Waste Permits Division Correspondence Cover Sheet

Re: Response to Technical Notice of Deficiency Letter
City of Meadow Landfill
Meadow, Terry County, Texas
Municipal Solid Waste Permit Number: 2293C
Tracking No. 30060987; RN101570976/CN606025534
Major Permit Amendment

NOD 1 TABLE

O:\0120\009\EXPANSION 2023\PARTS I-II\2.1-EXISTING AND PROPOSED LANDFILL FINAL COVER PLAN.dwg, jwilson, 1:2

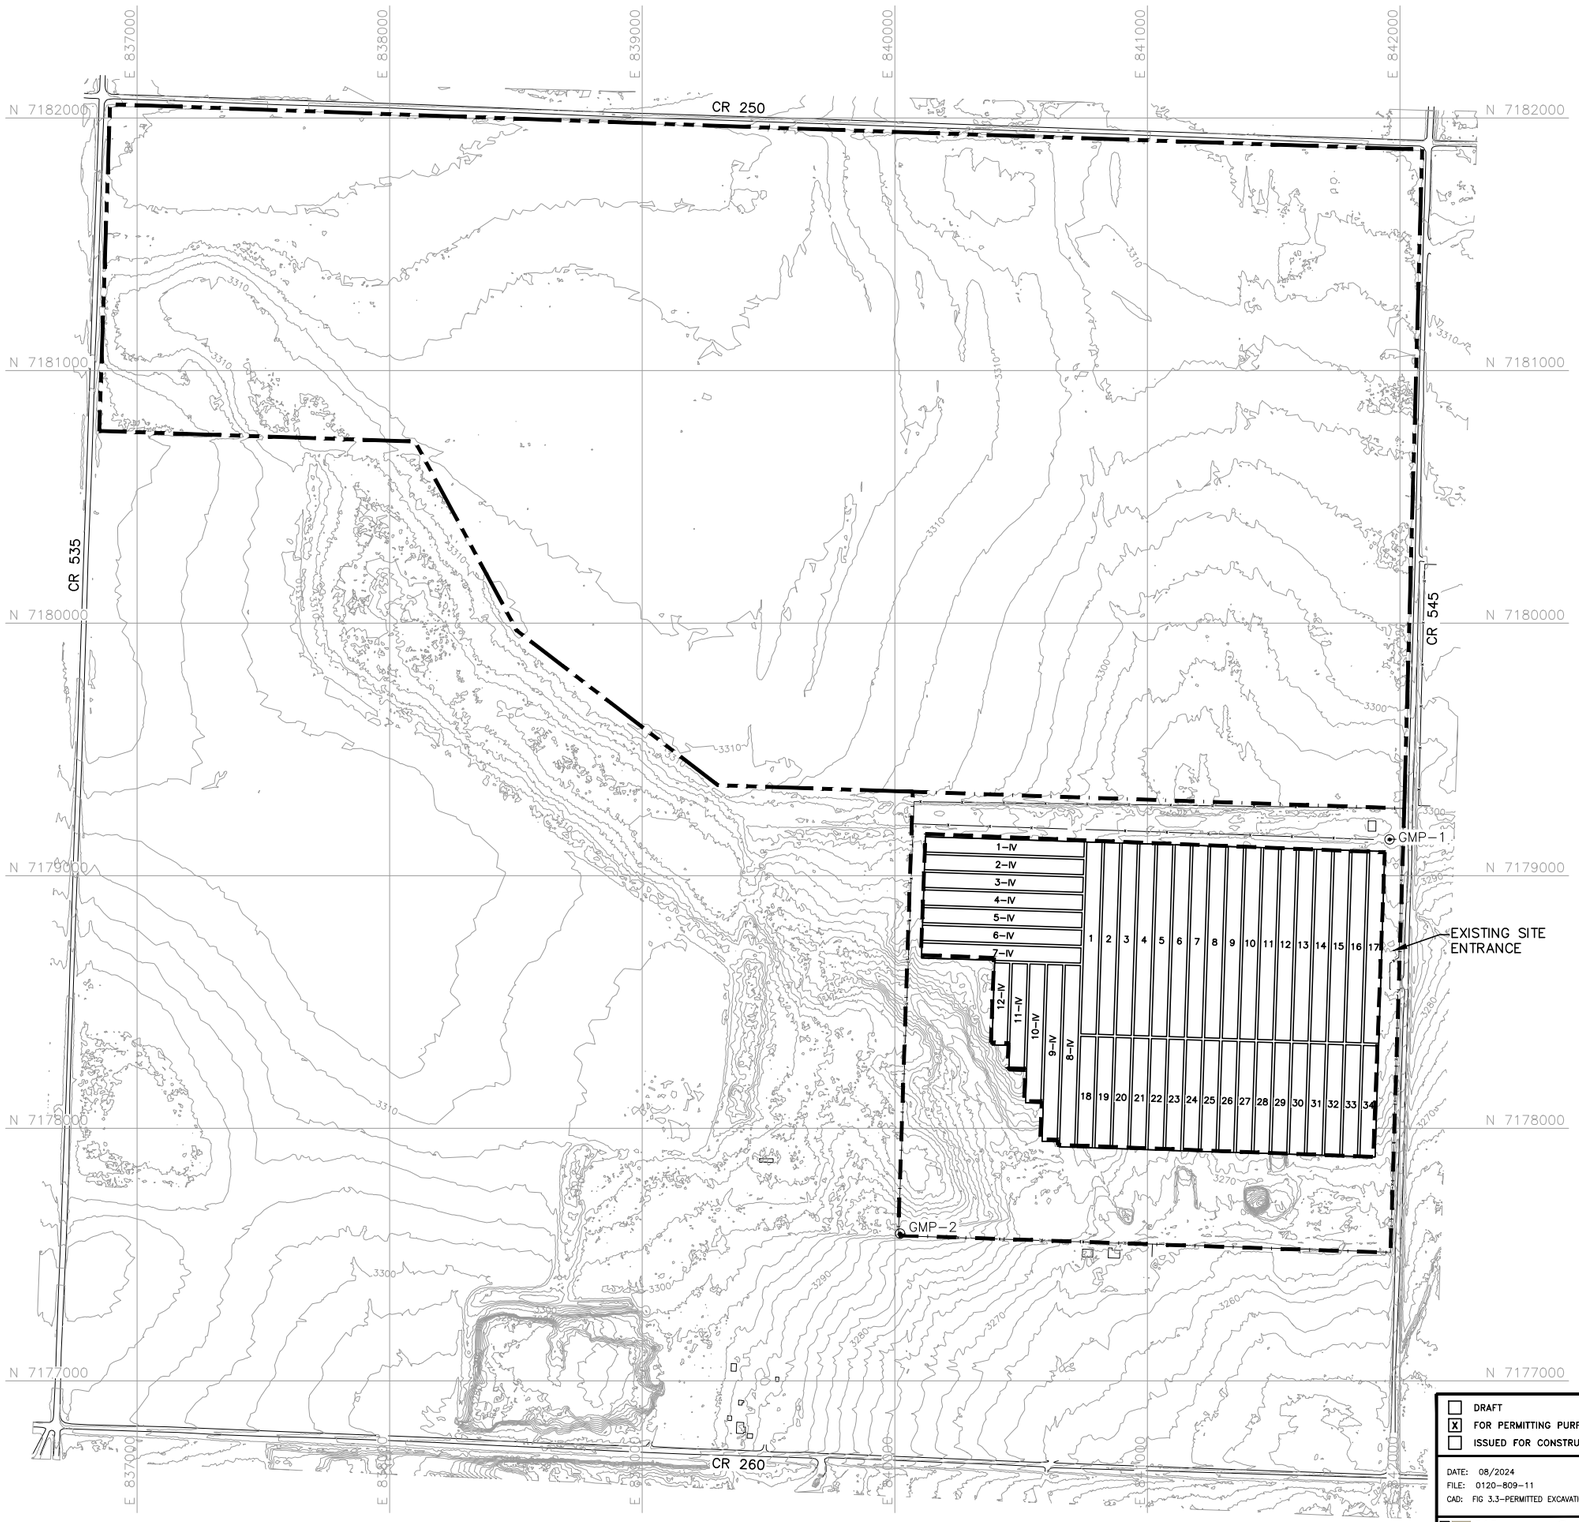
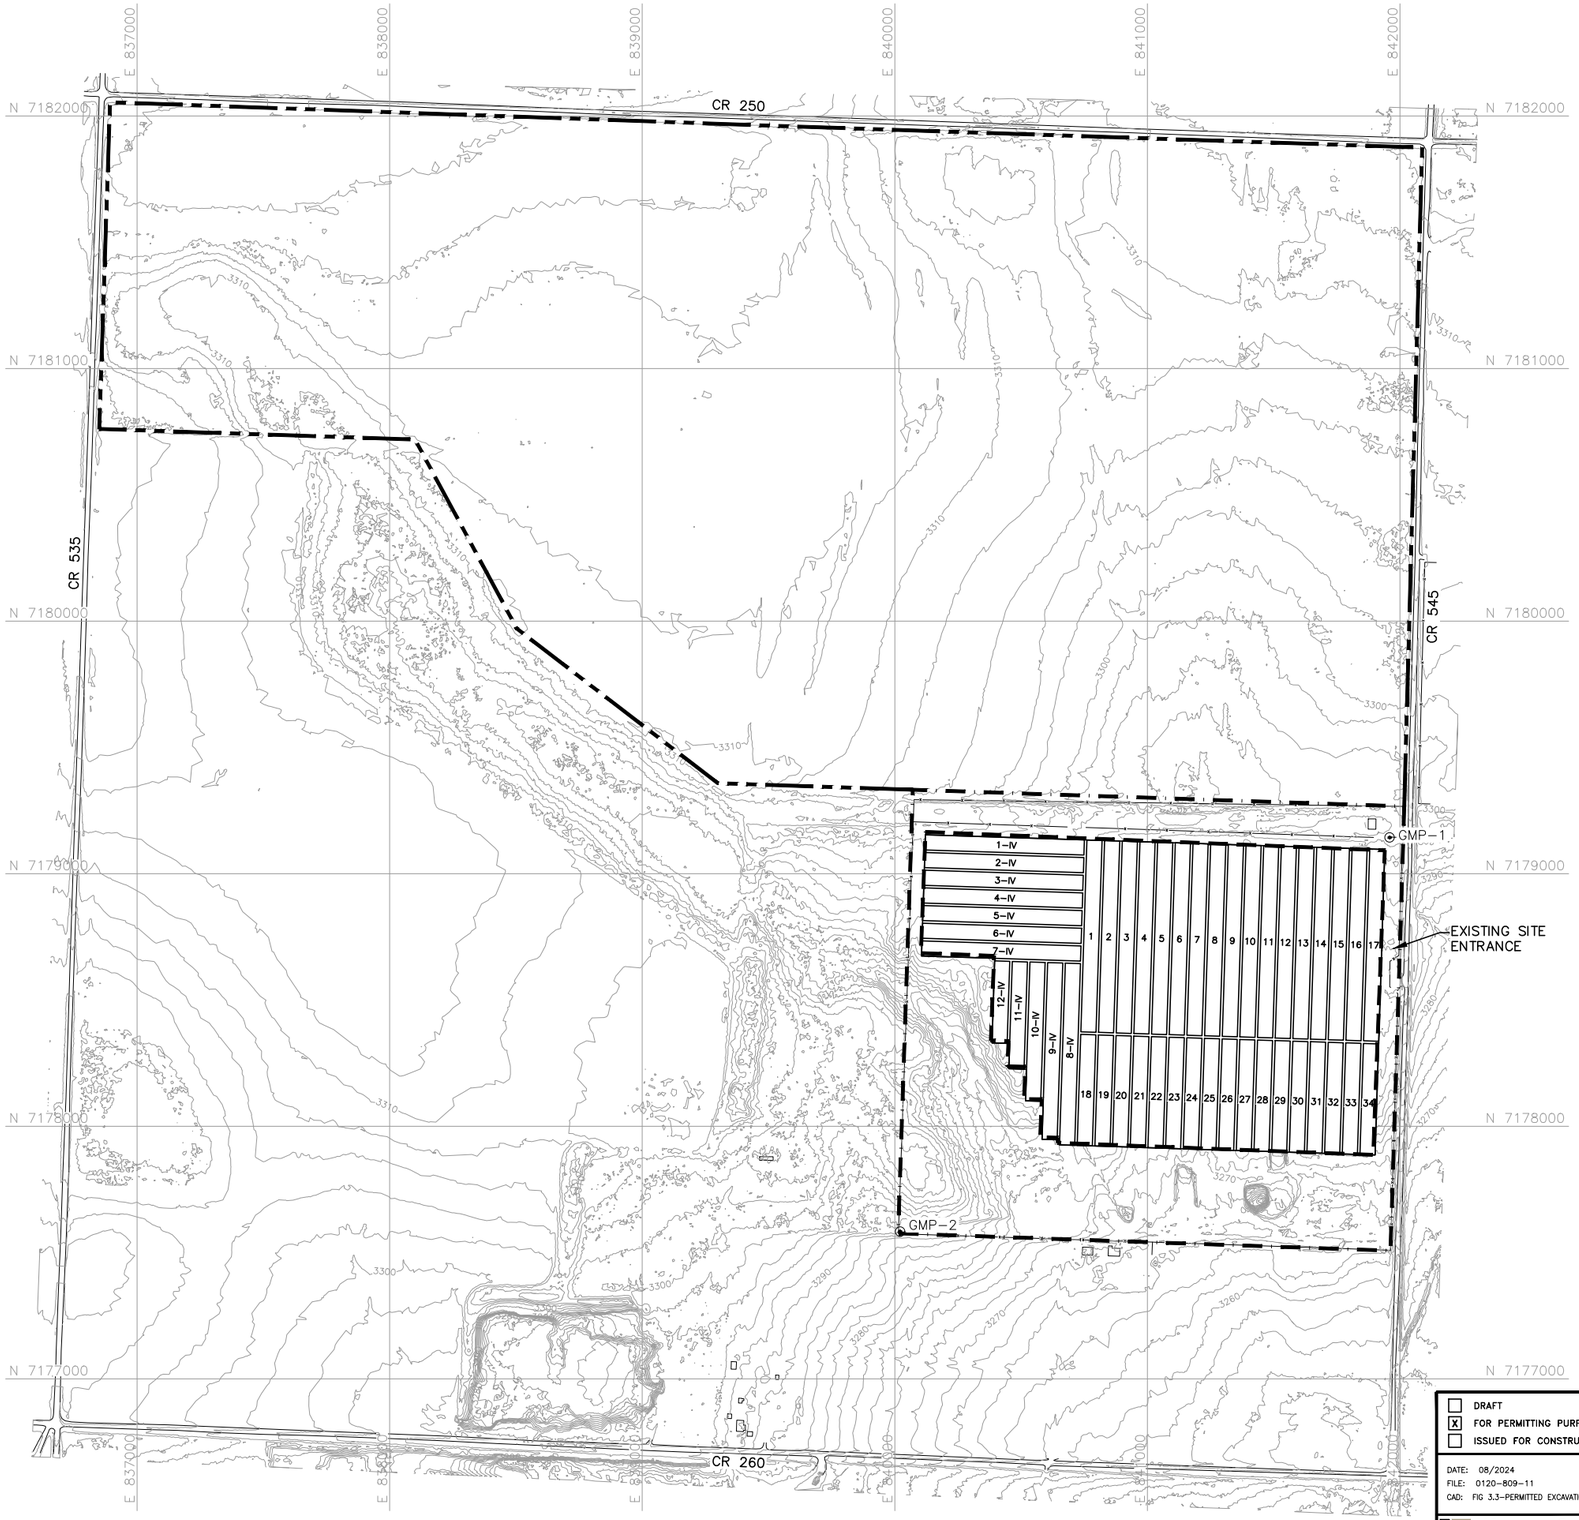
7	12	Part I/II, Section 2, Figure I/II-2.1	330.57(d)	Identify the arrows and structures colored in blue in the Legend. **Response:** Figure I/II-2.1 has been revised accordingly.
8	12	Part I/II, Section 2.1.1	330.57(d)	"*…the facility will not accept for disposal liquid waste (unless accepted for solidification…*" It is understood that the facility intends to accept liquid waste regularly and that all liquid waste will be solidified prior to disposal. Clarify under what circumstances liquid waste will not be accepted. **Response:** Parts I/II, Section 2.1.1 has been modified to state the affirmative that liquid waste will only be accepted for solidification and meeting the acceptance criteria for Special Waste as set forth in Part IV, Section 4.20 and Appendix IVC.
9	12	Part III, Appendix IIIJ	330.57(d)	Ensure that the title of Figure IIIJ-1 matches the title presented in the Table of Contents. **Response:** The Table of Contents List of Figures titles have been corrected.

O:\0120\809\EXPANSION 2023\PARTS I-II\4.2A-ASOS WIND ROSE.dwg, jwilson, 1:1

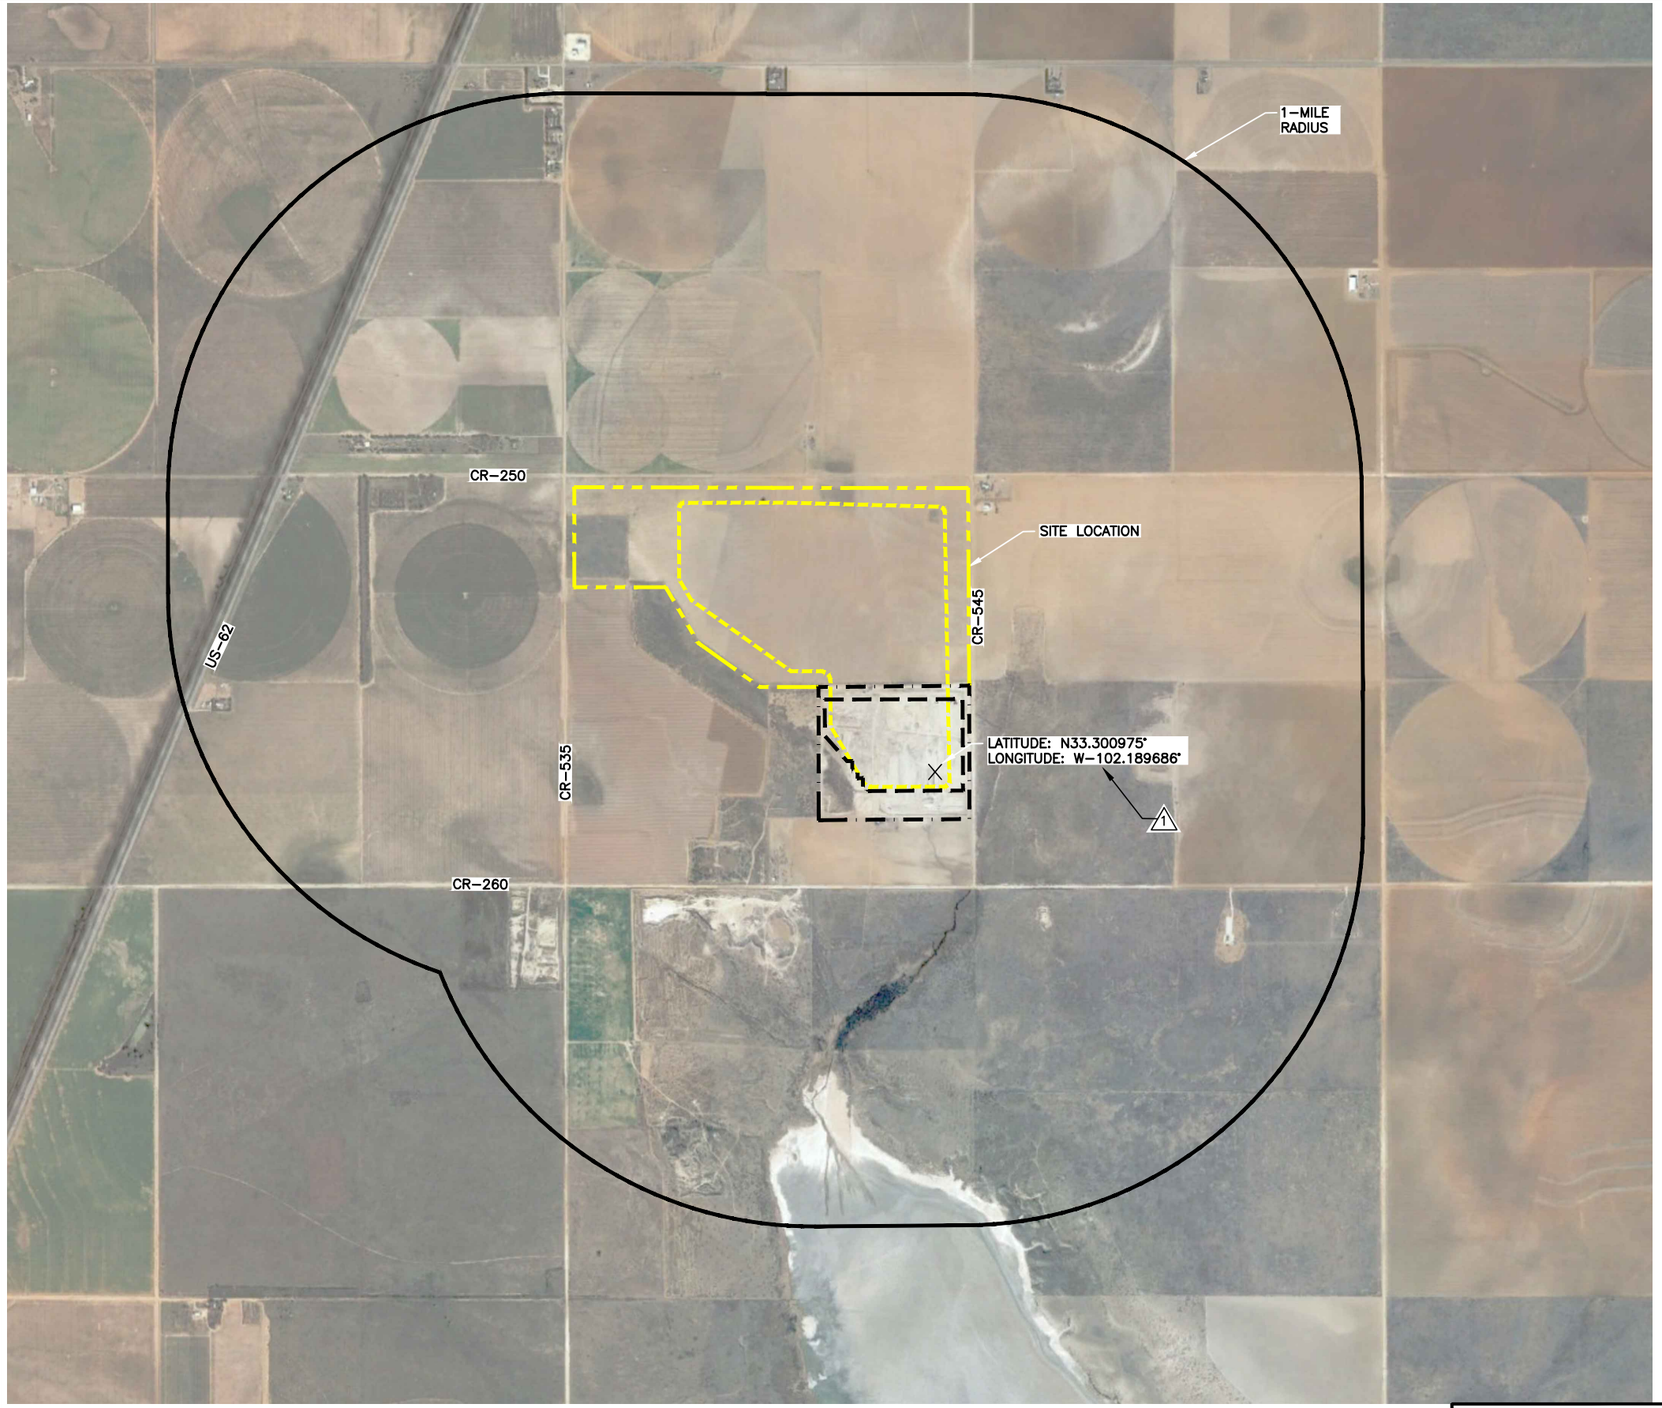
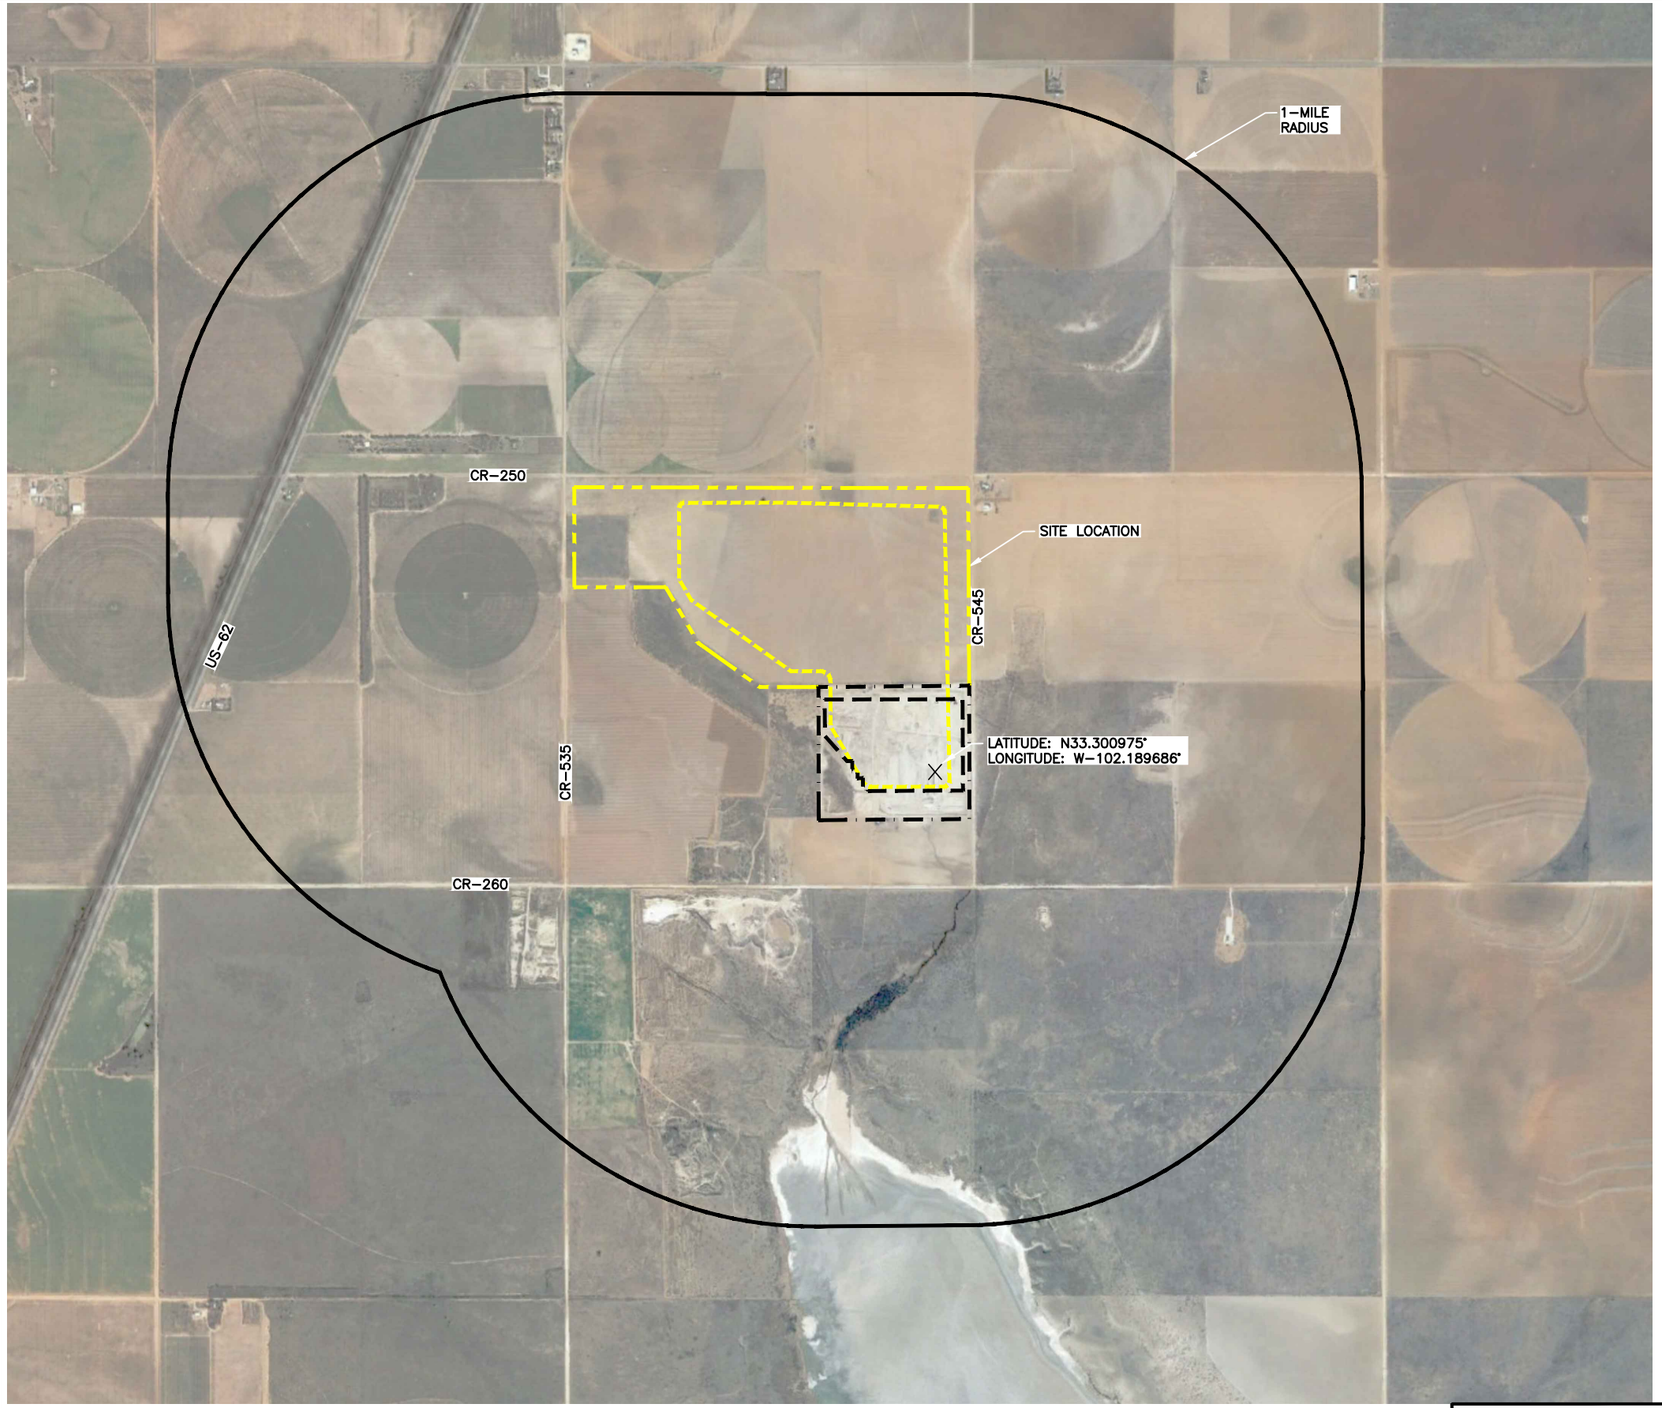
42	12	Waste Acceptance Plan Form	330.57(d)	The Waste Acceptance Plan Form states the contributing areas include the City of Meadow along with Terry and Lubbock counties. Appendix IIIM states that the service area will also include Cochran, Dawson, Gaines, Hockley, Lynn, and Yoakum counties. Please verify, correct, and adjust calculations accordingly. **Response:** The City of Meadow, Terry County and Lubbock County represent the currently anticipated primary service areas for the landfill. Appendix IIIM has been updated accordingly.
43	25	Part I/II, Section 4, Figure I/II-4.2	330.57(h)(1)	Revise map to use more legible radii callouts. **Response:** Radii callouts have been revised on Figure I/II-4.2 for clarity.
